ADMINISTRATIVE SHORT PLAT REPORT & DECISION

REPORT DATE:	March 29, 2010		
Project Name:	Dell Short Plat		
Owner:	Ryan Dell, 16018 114 th Avenue SE, Renton, WA 98055		
Applicant:	Same as owner		
Contact:	Same as owner		
File Number:	LUA10-007, SHPL-A		
Project Manager:	Gerald Wasser		
Project Summary:	<p>The applicant is requesting approval of an Administrative Short Plat for the subdivision of a 22,200 square foot parcel into three lots for the eventual development of two additional single-family residences. The proposed project is located in the Residential - 8 dwelling units per acre (R-8) Zone and would have a net density of 7.0 dwelling units per acre. Proposed Lot 1 would be 8,191 square feet, proposed Lot 2 would be 6,673 square feet and proposed Lot 3 would be 7,150 square feet in size. The existing single-family residence on proposed Lot 1 would remain. Access to all three lots would be from 114th Avenue SE with proposed Lots 1 and 2 taking access via a private access easement. The project is Categorically Exempt from SEPA regulations.</p>

DATE: February 18, 2010
TO: Jerry Wasser
FROM: Sonja J. Fesser *JSF*
SUBJECT: **Dell Short Plat, LUA-10-007-SHPL
Format and Legal Desc

NEIGHBORHOOD AND VICINITY MAP

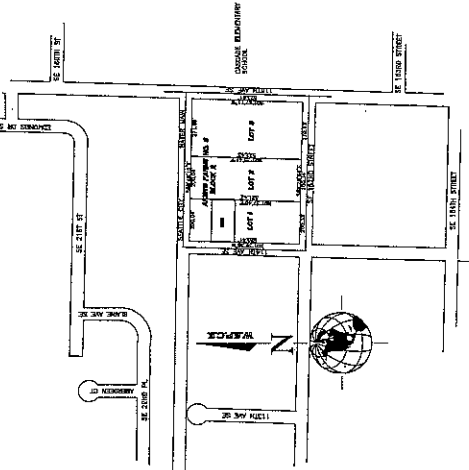
Note the scale on the vicinity map.

PROPOSED SHORT PLAT LAYOUT

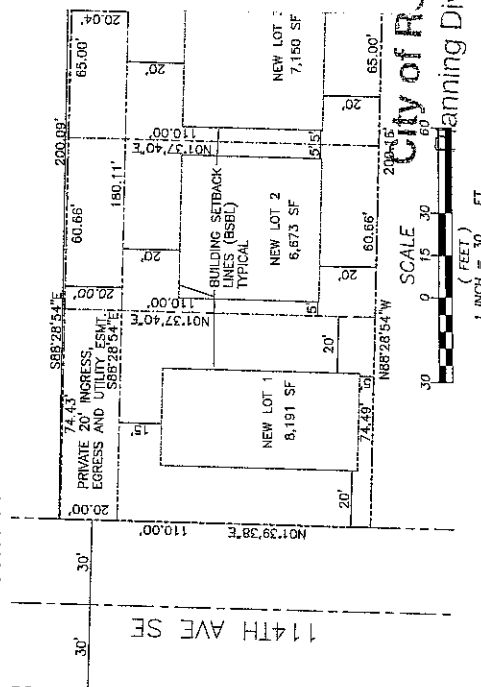
Do not include any references to density or zoning on the final submittal (currently shown in the "SHORT PLAT LEGEND" block on Sheet 1 of 2).

Remove the building setbacks shown on the "PROPOSED SHORT PLAT LAYOUT" map on Sheet 1 of 2.

RENTON
SCALE: 1"=20'
PROJECT NO. 0914
DRAWING FILE NAME: DELL-SHORT PLAT.DWG
SHEET 2 OF 2

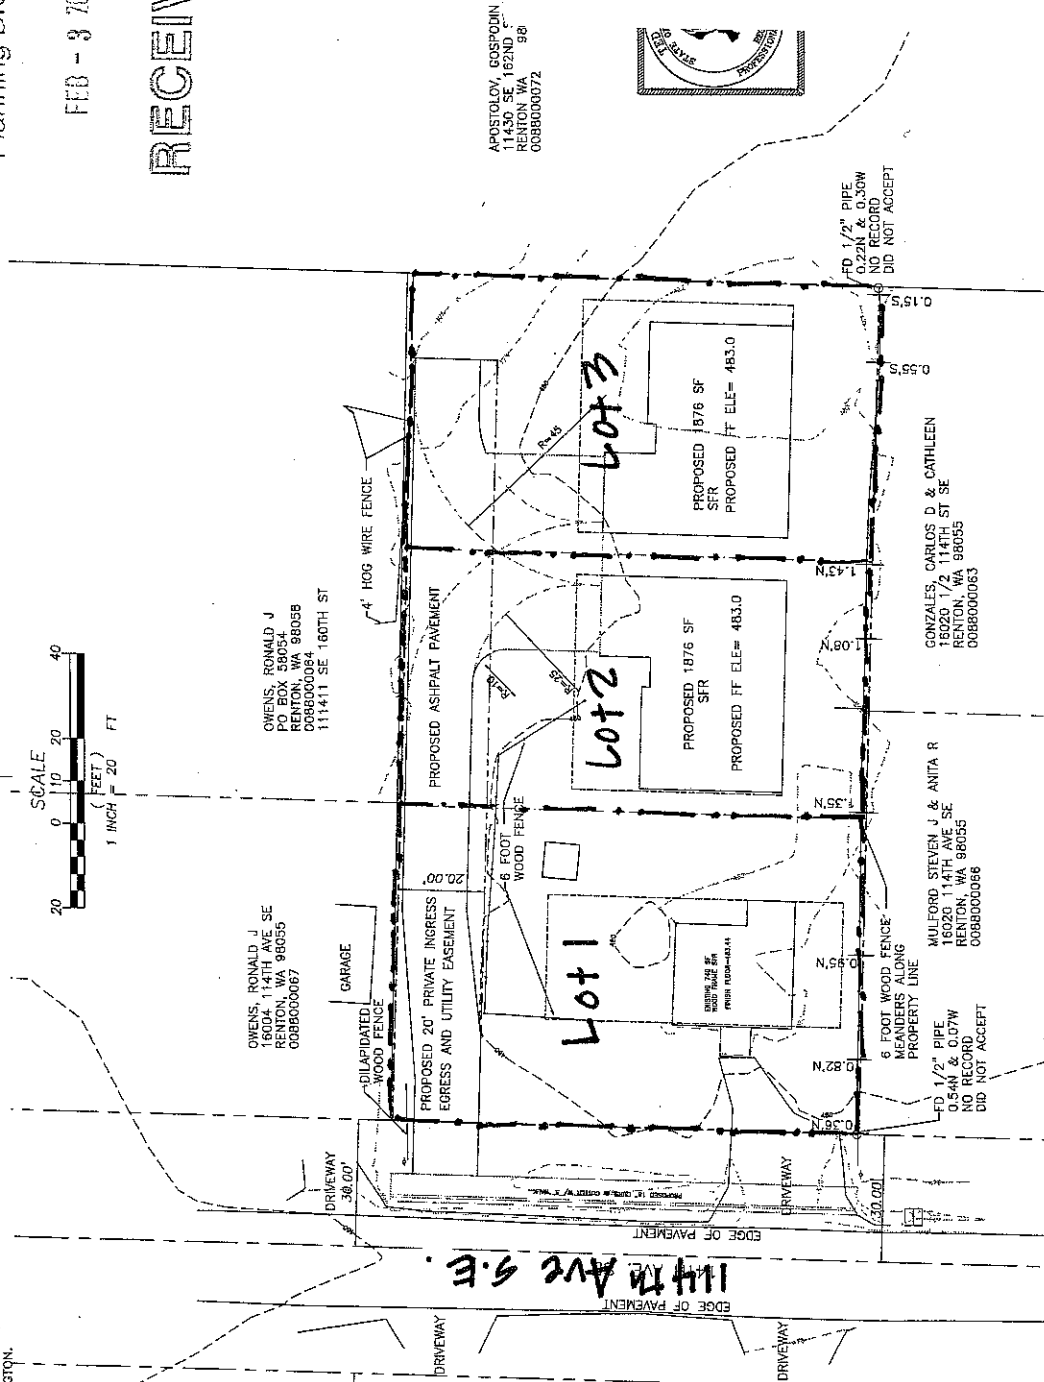
Show all the bearings and distances of the proposed lots on Sheet 2 of 2. It is assumed that this short plat drawing is the primary drawing for the short plat submittal.

Remove the King County tax lot numbers, property owner's names and addresses from the properties adjoining the subject short plat property. If said properties are platted, do note the lot numbers and plat name. (Sheet 2 of 2), if

Show the proposed easement on the submittal (Sheet 2 of 2) with the bearings and distances of said easement included.
